LOCAL HISTORIC DISTRICT: Dilworth

PROPERTY ADDRESS: 719 East Tremont Avenue

SUMMARY OF REQUEST: Brick piers

HDCADMRM 2019-00381

ELEV. OF BRICK PIER

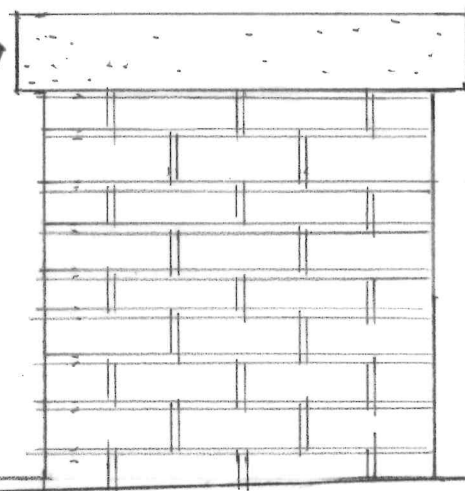
1. Massing, scale, painted brick.
2. The proposed brick piers are incongruous in both size and location to the smaller cottages and bungalows along E. Tremont and E. Worthington Avenue in the Dilworth local historic district.
3. Piers flanking a walkway are not a historic landscape element, and do not follow the historic design precedent of the surrounding environment, per Sidewalks and Parking Guidelines 8.2, item 2.
4. Piers flanking a walkway are conjectural features and should be avoided, per Standard #3 above.
